To the Point

TO: Bennett Commercial Pump Co. Distributors
FROM: Gary Hanks
BULLETIN NO.: 14
DATE: February 4, 2002
SUBJECT: VR10 Extended Price Computer Options with new style chassis (spec 2001) 4000 Heritage series dispensers

Model 500 Western Pulsers with
#7000I-11 Interface Barrier

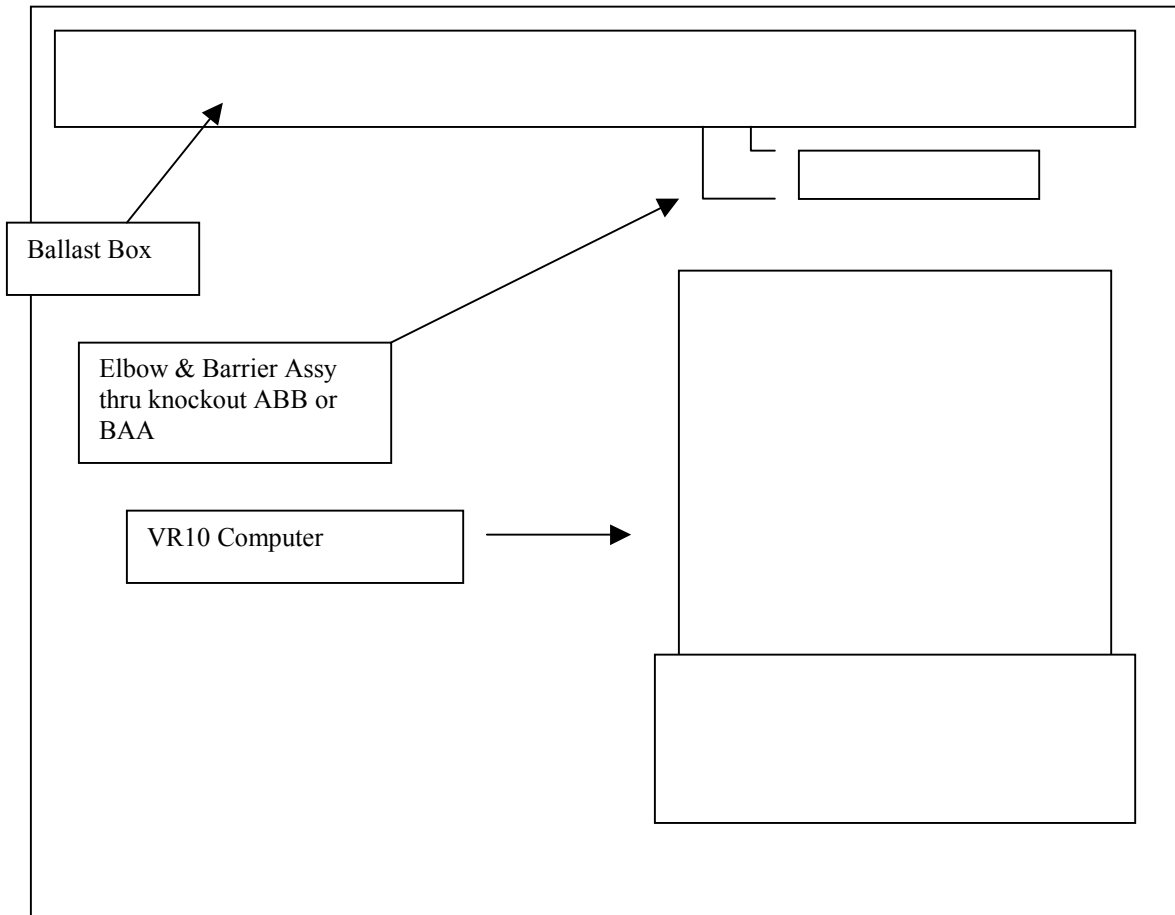
*Supply & Install 2 Western Pulser Model 500 including the 2 Western Interface Barrier for twin dispensers. For twin model dispensers, 2 of the Western #4500211 Short Shaft Kits are required. **The longer standard shaft kit will not fit in a twin dispenser.**

*In the bottom of the ballast box of the dispenser, there are knockouts that can be used to install the elbow (marked as ABB and BAA on the knockout). Install the elbow and barrier on the underside of the ballast box. Route the barrier wires to the terminal strip inside the ballast box.
